APPLICATION NO.	FILING DATE	FIRST NAMED INVENTOR	ATTORNEY DOCKET NO.	CONFIRMATION NO.
10/576,880	04/21/2006	Yoon-Seob Eom	P-0773	5874
34610 7590 03/31/2009 KED & ASSOCIATES, LLP P.O. Box 221200 Chantilly, VA 20153-1200				
EXAMINER				
RAHIM, AZIM				
ART UNIT		PAPER NUMBER		
3744				
MAIL DATE		DELIVERY MODE		
03/31/2009		PAPER

### Office Action Summary

## **DETAILED ACTION**

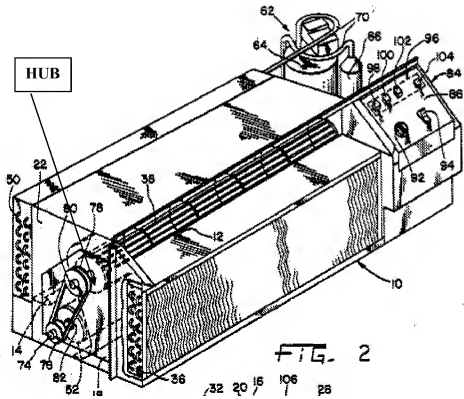
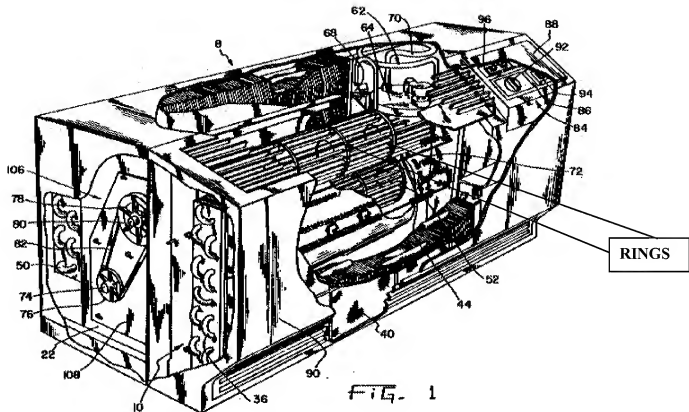
Regarding claim 1, Wollaber et al. teach an air conditioner (figs. 1-3) comprising: a case (8) of which one side is positioned at an indoor side (side adjacent to indoor heat exchanger 36) and another side is positioned at an outdoor side (side adjacent to outdoor heat exchanger 50); an indoor heat exchanger (36) mounted inside the case (illustrated in figure 3) positioned at the indoor side (illustrated in figure 3) thus to be heat-exchanged with the indoor air (46); an indoor

centrifugal fan (38) opposite to the indoor heat exchanger (illustrated in figure 3) for generating a blowing force so that the indoor air can pass through the indoor heat exchanger (the indoor heat exchanger is capable of performing this intended use function); an outdoor heat exchanger (50) mounted inside the case (illustrated in figure 3) positioned at the outdoor side (illustrated in figure 3) thus to be heat-exchanged with the outdoor air (54); and an outdoor centrifugal fan (52) opposite to the outdoor heat exchanger (illustrated in figure 3) that generates a centrifugal force to blow the outdoor air [this intended use limitation is capable of being performed by the outdoor centrifugal fan], wherein the outdoor centrifugal fan comprises: a hub (annotated below) formed in a disc shape (illustrated in figures 1-3) connected to a driving motor (72) by a rotational shaft (74); a plurality of blades (annotated below) each having one end protruding from a surface of the hub (illustrate in figure 3) and disposed at the outer side of the hub in a circumferential direction (illustrated in figure 3) with the same interval therebetween (illustrated in figure 3); and a supporting ring (the ring as annotated below) coupled to another end of each of the plurality of blades to support the blades [as illustrated in figure 3, portions of the ring are disposed in a vicinity between the blades]. It is noted that the Applicant has not specified the boundaries of the indoor side and the outdoor side.

Regarding claim 2, Kang et al. teach the limitation of an outdoor air suction port (area where outdoor air 54 enters the air conditioner) being respectively formed at both lateral surfaces of the case (as illustrated in figure 3, since the outdoor suction port has a surface area, it is disposed at "lateral sides" of the case) positioned at the outdoor side (illustrated in figure 3), and

an outdoor air discharge port (34) is formed at the rear surface of the case (illustrated in figure 3).

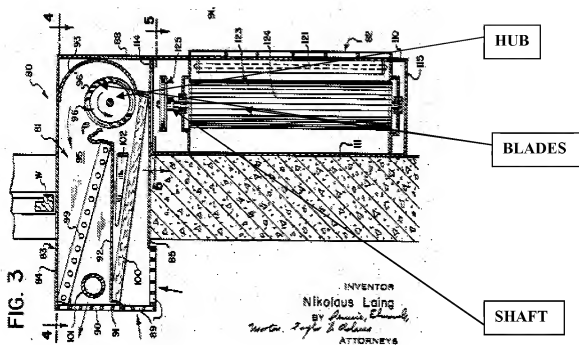
Regarding claim 1, Laing teaches an air conditioner (figs. 1-2) comprising: a case (1) of which one side is positioned at an indoor side (side adjacent to indoor heat exchangers 13 and 14) and another side is positioned at an outdoor side (side adjacent to outdoor heat exchanger 3); an indoor heat exchanger (13 and 14) mounted inside the case (illustrated in figure 1) positioned at the indoor side (illustrated in figure 1) thus to be heat-exchanged with the indoor air (illustrated in figure 1); an indoor centrifugal fan (12) opposite to the indoor heat exchanger (illustrated in figure 1) for generating a blowing force so that the indoor air can pass through the indoor heat exchanger (the indoor heat exchanger is capable of performing this intended use function); an outdoor heat exchanger (35) mounted inside the case (illustrated in figure 1) positioned at the outdoor side (illustrated in figure 1) thus to be heat-exchanged with the outdoor air (illustrated in figure 1); and an outdoor centrifugal fan (36) opposite to the outdoor heat exchanger (illustrated in figure 1) that generates a centrifugal force to blow the outdoor air [this intended use limitation is capable of being performed by the outdoor centrifugal fan], wherein the outdoor centrifugal fan comprises: a hub (annotated below) formed in a disc shape (illustrated in figure 3) connected to a driving motor (53) by a rotational shaft (annotated below); a plurality of blades (annotated below) each having one end protruding from a surface of the hub (illustrate in figure 3) and disposed at the outer side of the hub in a circumferential direction

(illustrated in figure 3) with the same interval therebetween (illustrated in figure 3); It is noted that the Applicant has not specified the boundaries of the indoor side and the outdoor side.

Laing fails to explicitly teach a supporting ring coupled to another end of each of the plurality of blades to support the blades.

Wollaber et al. teach an air conditioner [illustrated in figures 1-3] comprising a blower (52) that includes blades [annotated above] that are supported by rings [annotated above].

It would have been obvious to one having ordinary skill in the art at the time the invention was made to have modified the air conditioner of Laing to include the rings as taught by Wollaber et al. in order to prevent the fan from deforming or bending during operation of the air conditioner, thus minimizing noise and vibration.
